Record of Executive Business and Chief Executive's Order

Reg. Reference: SD22A/0039 **Application Date:** 10-Feb-2022

Proposed Development: (a) The demolition of two existing habitable structures on site including a bungalow (Silveracre), an existing cottage (No. 6 Whitechurch Road) and a row of 5 derelict structures/cottages located along the western boundary of the site (extent of proposed demolition is 433sq.m) (b) the construction of 22 4 bed, 3-4 storey units ranging in size from 197sq.m to 214sq.m, all with associated private balcony/terrace areas. Vehicular and pedestrian access is proposed via new entrance on Whitechurch Road. The proposed development shall provide for 44 car parking spaces, a new single storey bicycle storage shed (approx 34sq.m) and provision of bin storage to be provided at the front curtilage of the dwelling for all terraced units, all boundary treatment, all site services and all associated site works.

Location: Silveracre Bungalow, Whitechurch Road,
Rathfarnham, Dublin 14.

Figure 3 footpath

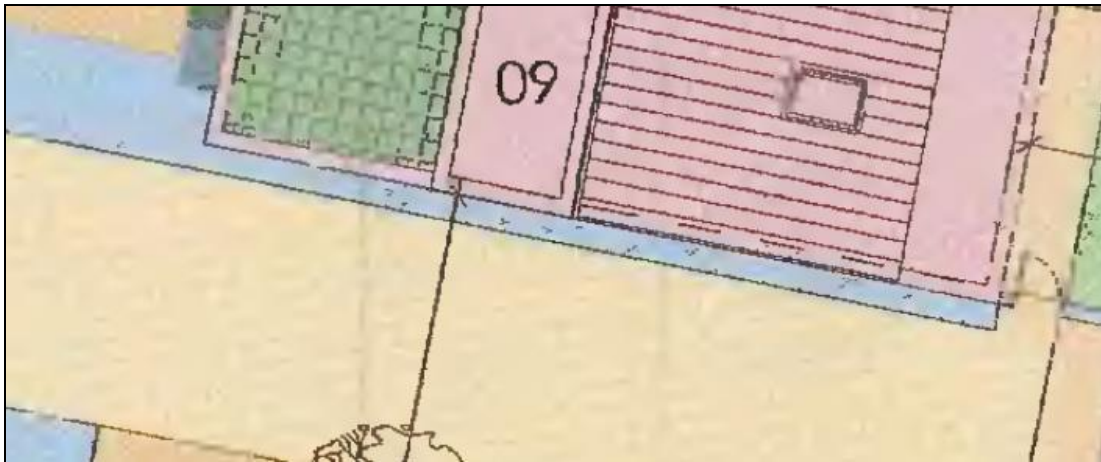
Pedestrian permeability within the development is good. There are two proposed pedestrian access and three of the roads are to be shared surfaces. The footpaths are proposed to be 1.8m wide where provided. It is not clear from the drawing if the footpath alongside unit 9 is 1.8m wide or if it is a shared space between vehicles and pedestrians, this should be confirmed. A pedestrian link to Tara Hill estate through the east would be welcomed, to increase the permeability for the surrounding dwellings.

It is proposed to provide a 1.8m wide footpath along the front of the development along Whitechurch Road, this must connect to existing walking infrastructure. The existing walking and cycling infrastructure along Whitechurch Road are very poor and improvements are welcomed. The footpath is narrow 0.7m in places. There is no footpath to the north towards Ballyboden Road/Willbrook Road, potentially the strongest pedestrian desire line towards Rathfarnham Village and public transport. There is a potential pedestrian route through Willbrook Grove towards Ballyboden Road, that could be accessed by uncontrolled pedestrian crossing from the proposed development across Whitechurch road over the bridge at the whitechurch stream.

3. *The applicant/developer is requested to submit a revised layout not less than 1:100 scale showing the pedestrian routes within the development.*
 - a. *The minimum width of footpaths shall be 1.8m wide to aid mobility impaired users.*
 - b. *Footpath layout shall provide adequate connectivity around the development and footpaths on the main road.*
